Addendum No. 3

REBID TRUCKEE CANYON WATER SYSTEM EXPANSION

PWP Bid No. WA-2016-158
June 10, 2016

2.8 SILENT CHECK VALVES

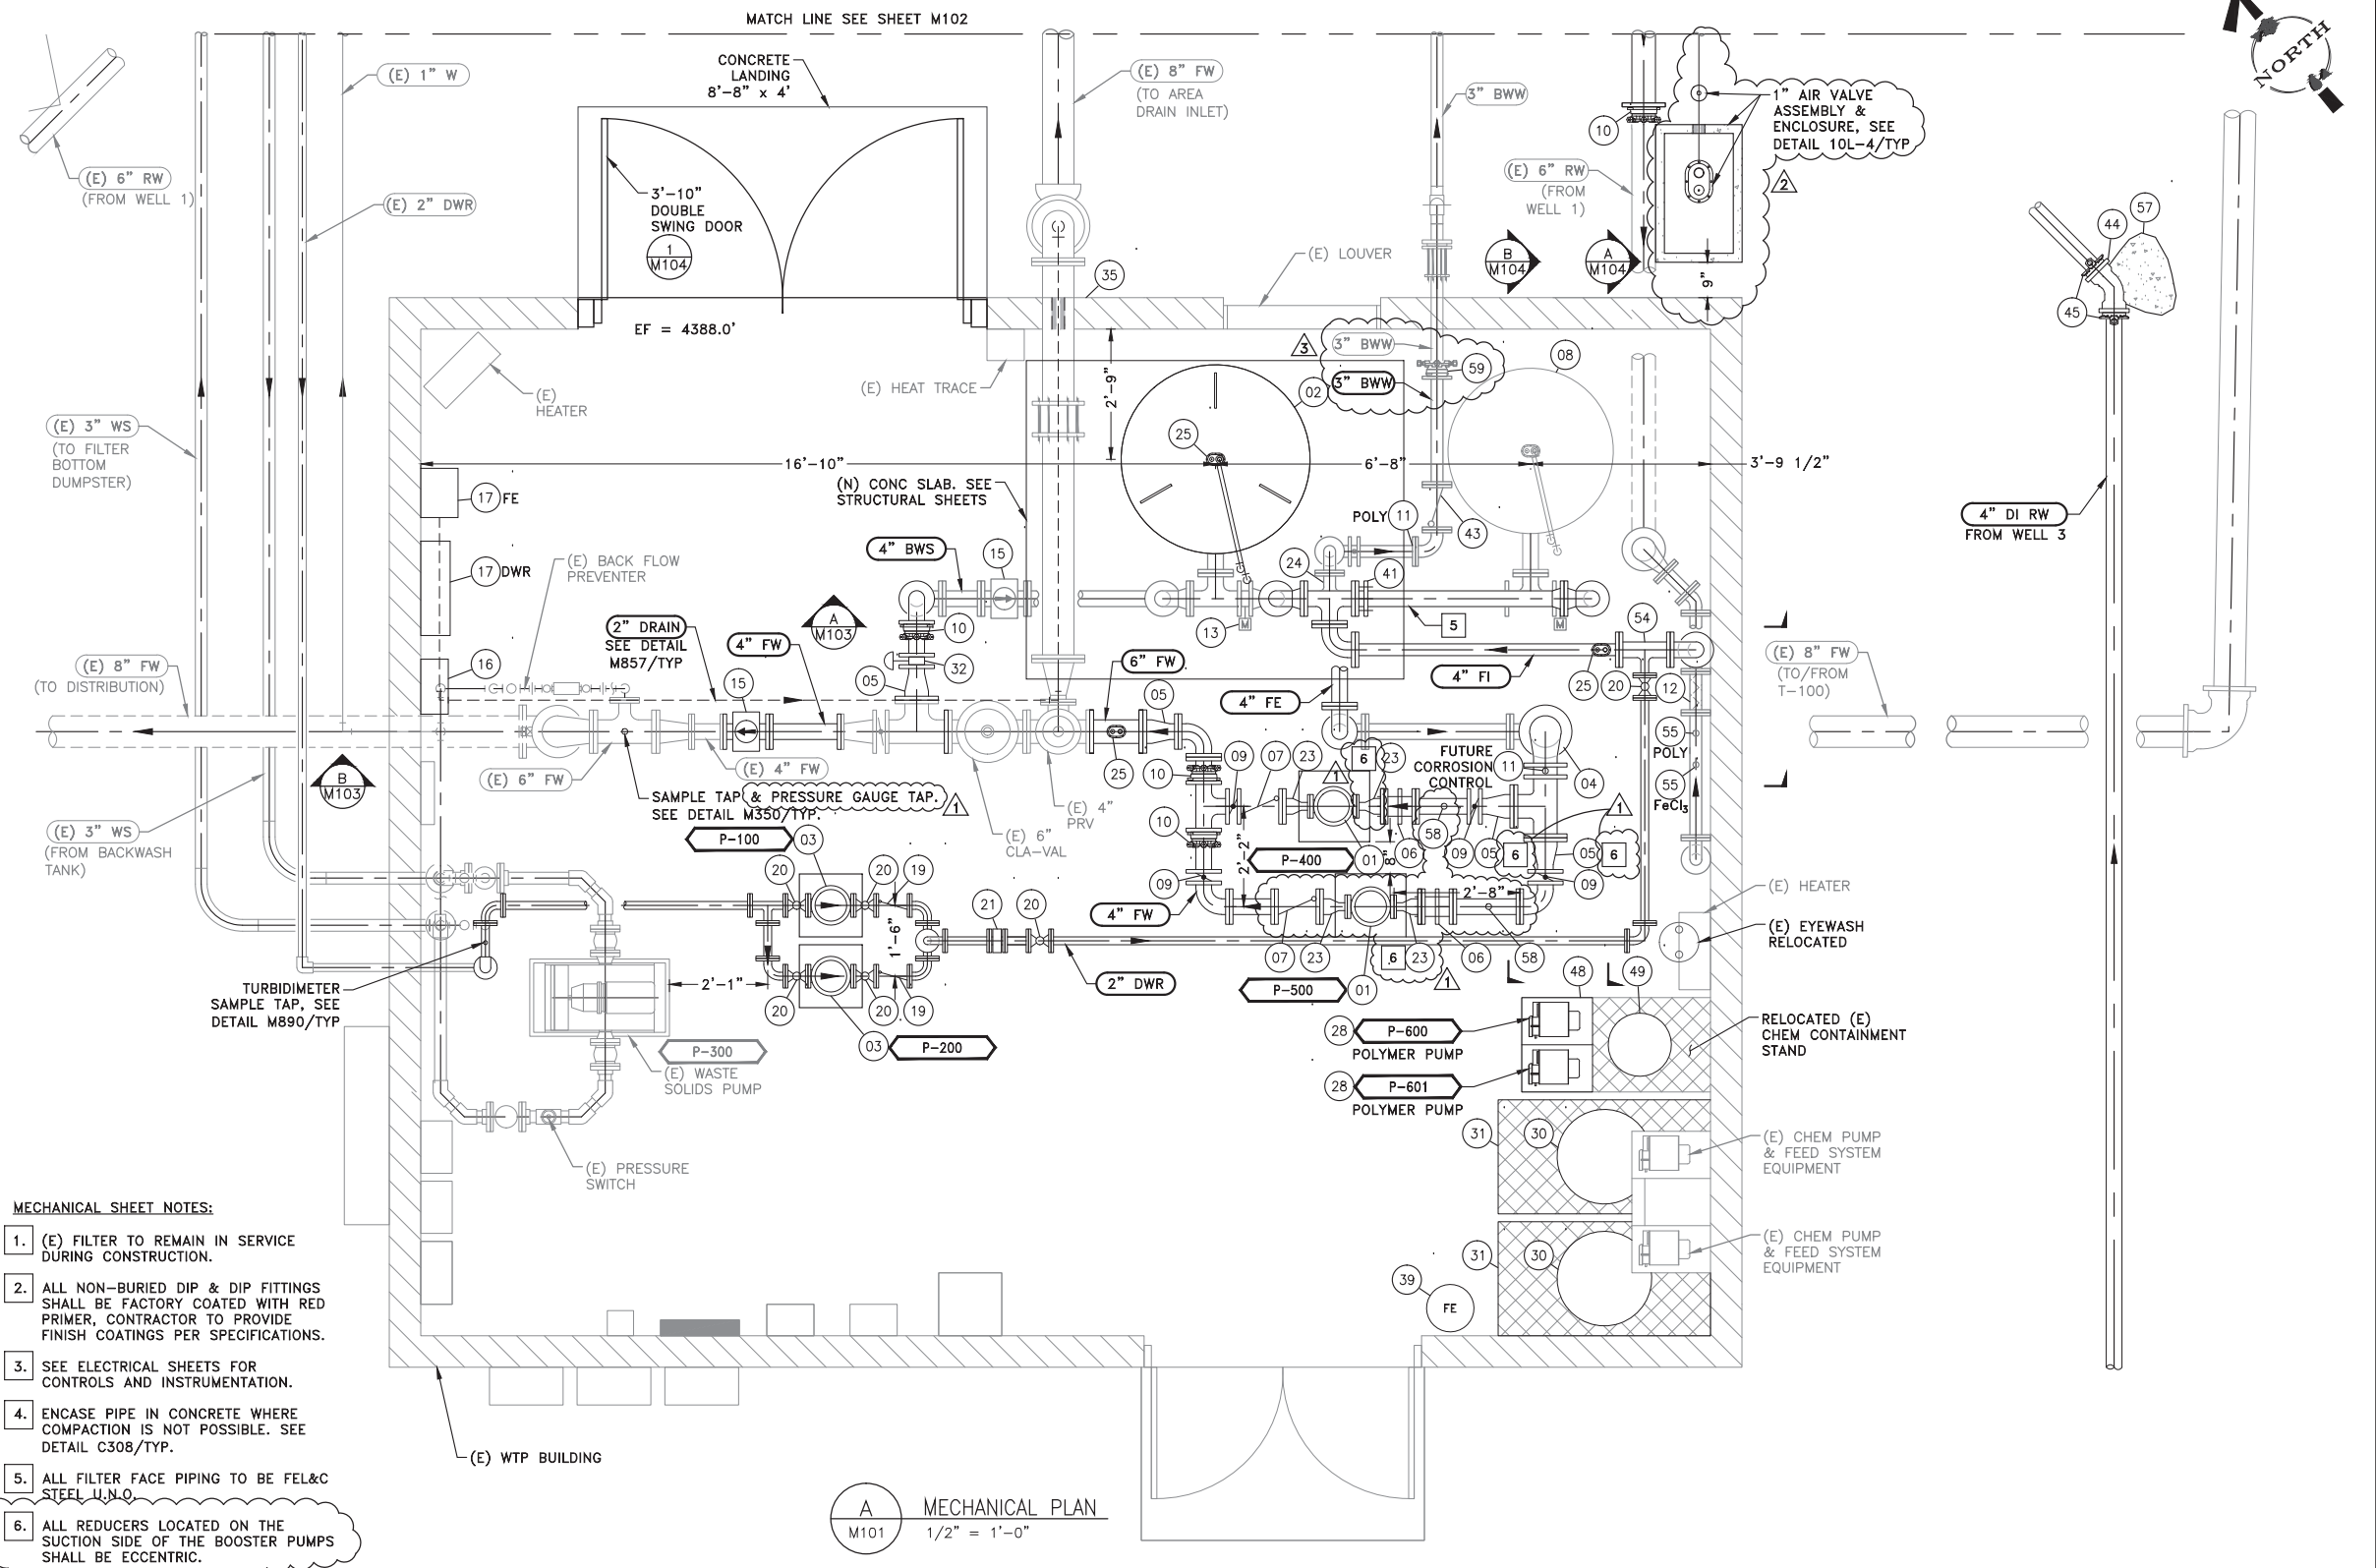
Question No. 1: Item #7 on sheet M101 is a 4" silent check valve. Please provide a spec for the silent check valve.

Response to Question No. 1: Please see attached specification section 15100 for the addition of silent check valve requirements

APCO series 600 globe style, full body, ductile iron, pressure class 150, with flanged ends, or approved equal. The valve plug shall be center guided at both ends with a through shaft and spring loaded. The seat and plug shall be hand replaceable in the field. The flow area through the body shall be equal to or greater than the cross-sectional area of the equivalent pipe size.

SHEET NUMBER
M101
 27 OF 53

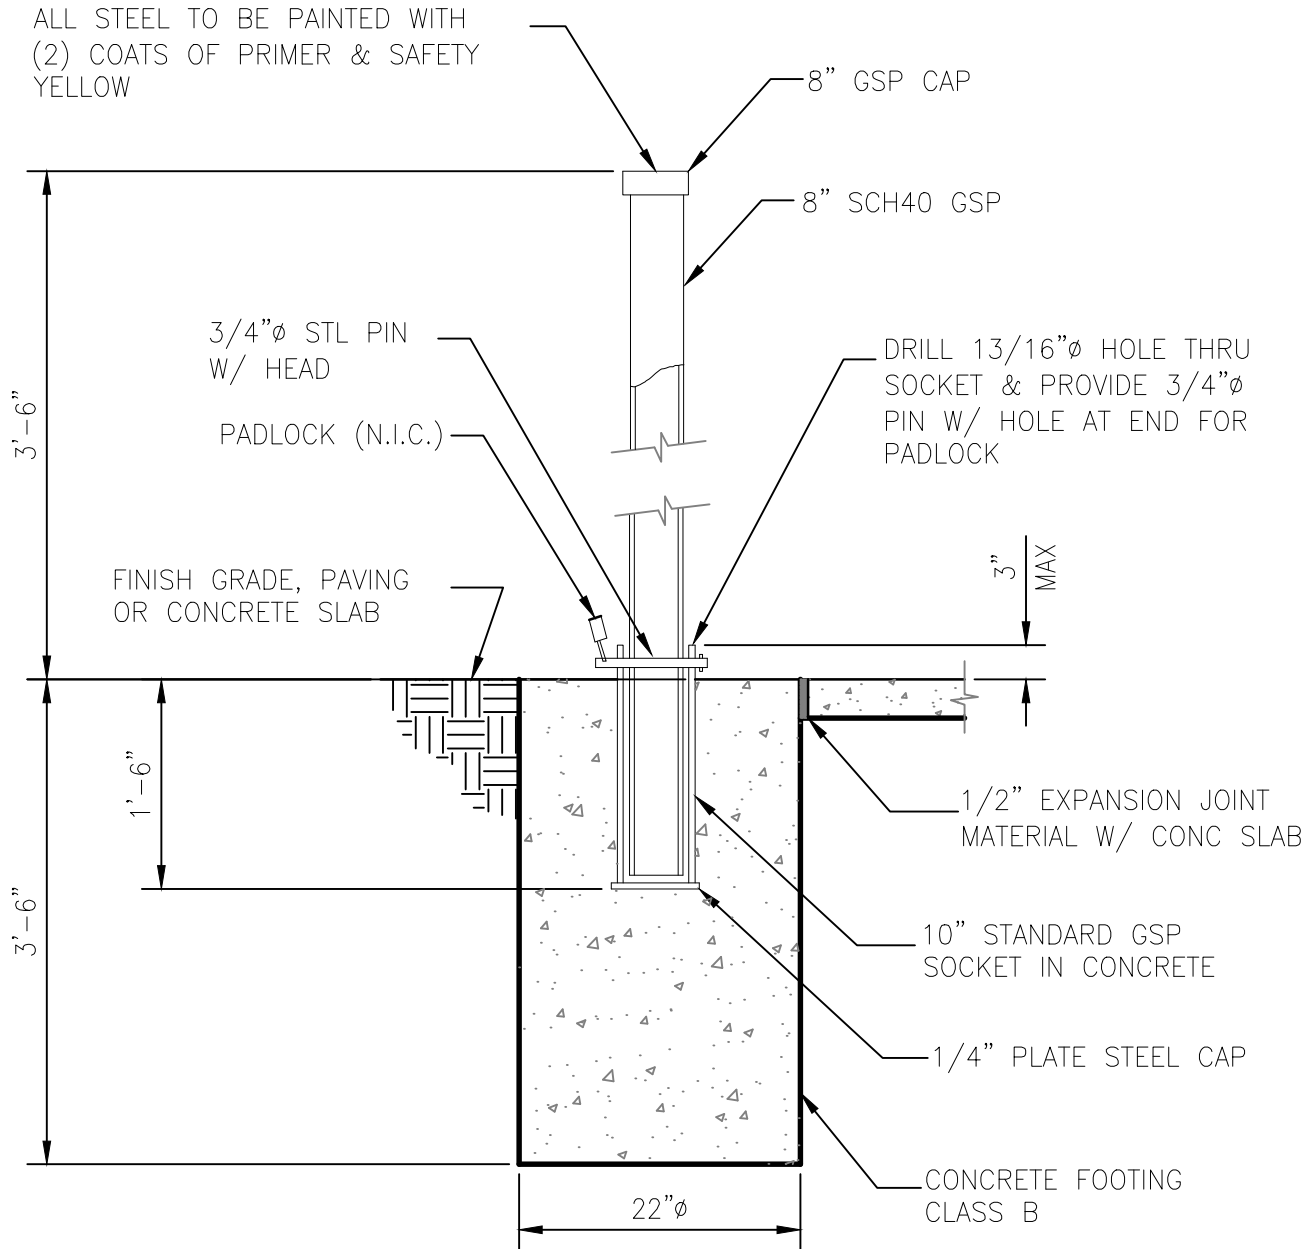
Question No. 5: The 3” PTW has two connections to existing on sheet M102. Since the PTW line is scheduled as ductile iron pipe it is unclear how the new line connects to the existing line after the 3” BFVs (item #37). Please clarify.

Response to Question No. 6: For clarification, please see the attached M101 sheet for new and existing pipe callouts. The flange coupling adapter (equipment tag no. 42) was changed to a restrained flange coupling adapter.

Sheet Number	Page(s)	Description of amendment
M101	27	See M101 for new and existing pipe callouts. The flange coupling adapter (equipment tag no. 42) was changed to a restrained flange coupling adapter.
